A Planning Proposal (PP\_2017\_SYDNE\_007\_00) for the Sydney Metro Martin Place Station Precinct was formally lodged with the Department of Planning and Environment (Department) on 19 June 2017, with the Secretary of the Department, the Relevant Planning Authority (RPA). This Planning Proposal sought to amend certain development standards applying to the Precinct via a site-specific provision in the *Sydney Local Environment Plan 2012* (Sydney LEP) that:

This report, prepared by Ethos Urban (formerly known as JBA) on behalf of the proponent, sets out the response to each of these issues raised in the submissions, on an issue by issue basis. Where individual issues have not been discussed in this report, these issues have been addressed in a detailed response which can be found in the table in **Appendix A**.

**Figure 3 – View from MLC Centre Level 10**

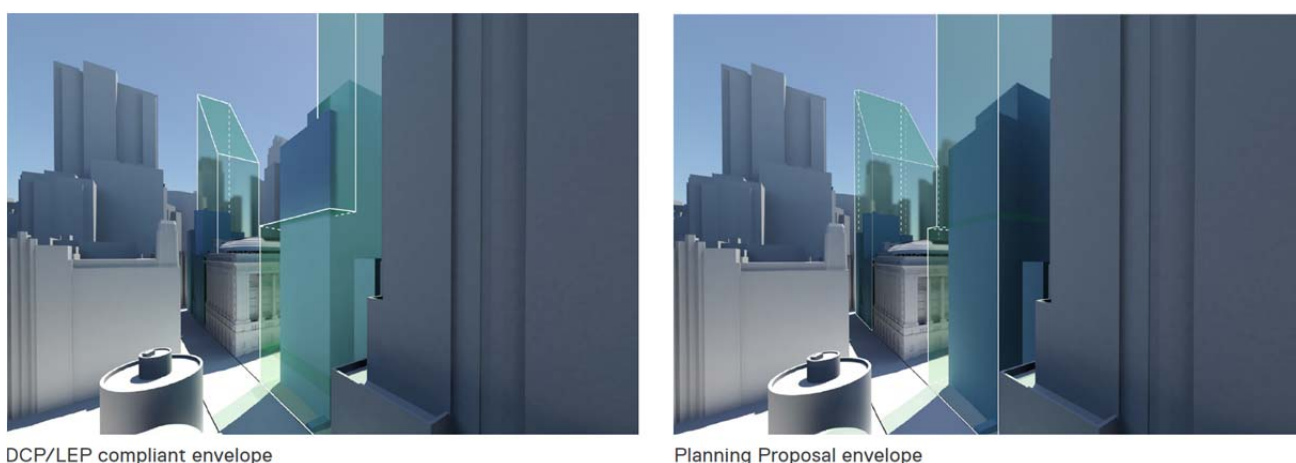
- The MLC Centre appears in the distance of View D (from Chifley Square looking south). Views have not been selected to allow analysis of the impact of the Proposal for the South Site on the MLC Centre.

In response to concerns raised regarding impacts to views from the MLC Centre forecourt and tower, a focussed View Impact Analysis has been prepared by Grimshaw (**Appendix B** of this report) which models the change in views, as a result of the Planning Proposal envelope, compared to the existing LEP / DCP envelope. Whilst the Planning Proposal envelope will result in a change in views from the MLC Centre tower and forecourt, this will not adversely or unreasonably impact on the amenity of the MLC Centre for the following reasons:

- The change to existing views resulting from the Planning Proposal Envelope compared to an existing LEP / DCP envelope is minimal, with the Planning Proposal Envelope not blocking any significant views. Whilst it is recognised that there is a need to maintain the amenity of surrounding development, given the commercial office use and CBD context of the Precinct, the proposed outlook change is considered reasonable.

**Figure 3 to Figure 8** below illustrates the minor nature of the additional view loss which results from the Planning Proposal Envelope compared to an existing LEP/DCP envelope.

**Figure 6 – View from front steps of MLC Centre looking north-east**

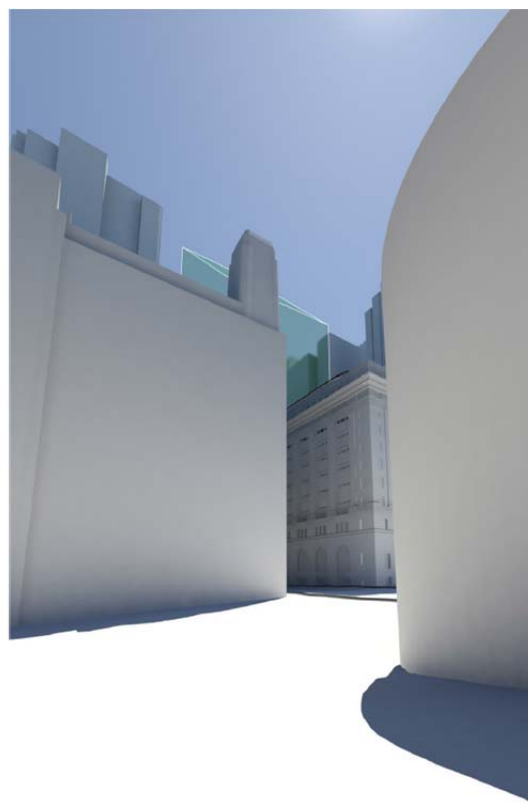
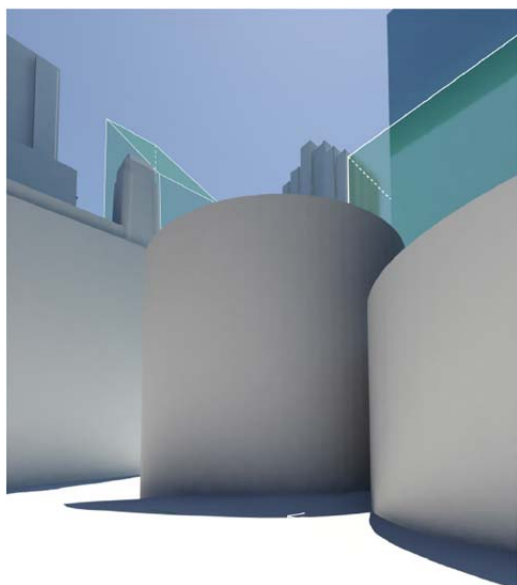
- The Planning Proposal will cause significant additional overshadowing of a public forecourt at MLC. The 25m tower setback on the south site has the effect of allowing sun to the MLC steps and public forecourt, and through the skylights to the basement retail areas. By not respecting the setback it will cause additional overshadowing of this area. The overshadowing is produced by the component of the tower that is proposed within the 25m tower setback above 55m.

- The Planning Proposal will result in increased overshadowing of the publicly accessible spaces on the MLC Centre site. This appears to have been ignored by the Planning Proposal because the MLC Centre is private land.

Figure 10 – Expansive 360 degree views available from the MLC Tower above level 30

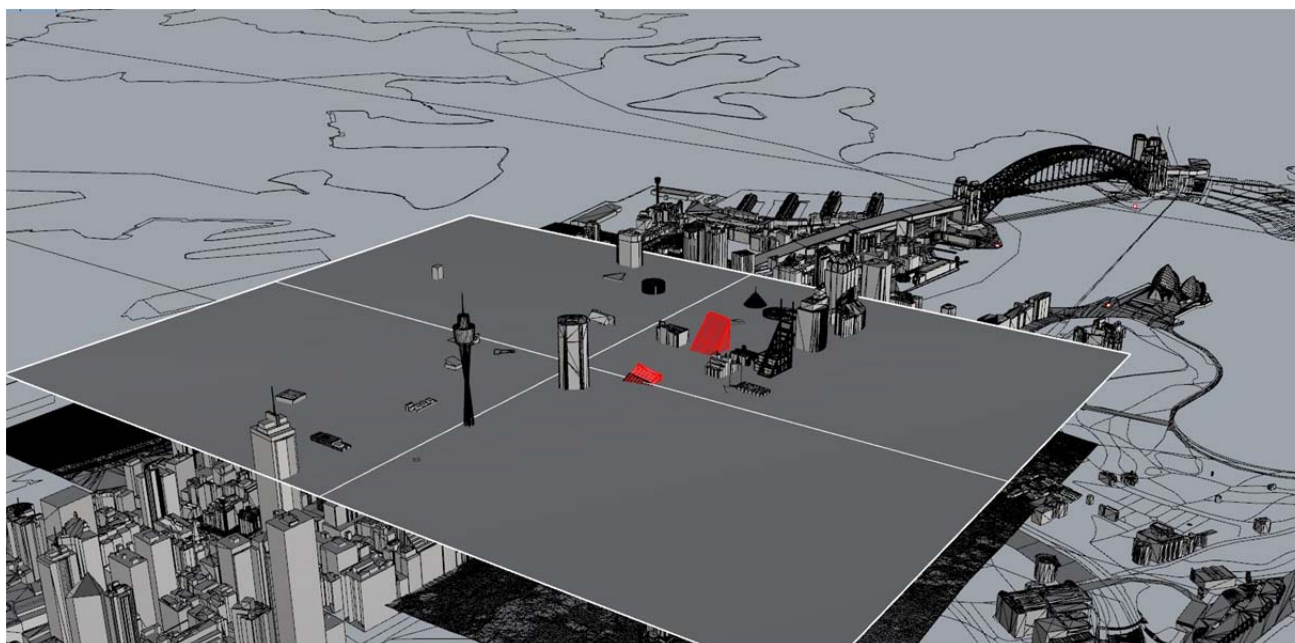
- The Planning Proposal package details no specific impacts on the MLC Centre, notwithstanding that the MLC Centre is the immediate neighbour to the west of the "south site" and that it is prone to adverse overshadowing, wind conditions and other impacts including on publicly accessible space within the MLC Centre site, by virtue of increased bulk, scale and height on the "south site".

- The MLC building is a tower in the round, and taller than most other buildings, so view impacts need to be considered in this context. The MLC Tower above Level 30 has expansive 360 degree views of the CBD and beyond to the harbour and to other iconic views that will continue to be protected (refer to **Figure 10**).
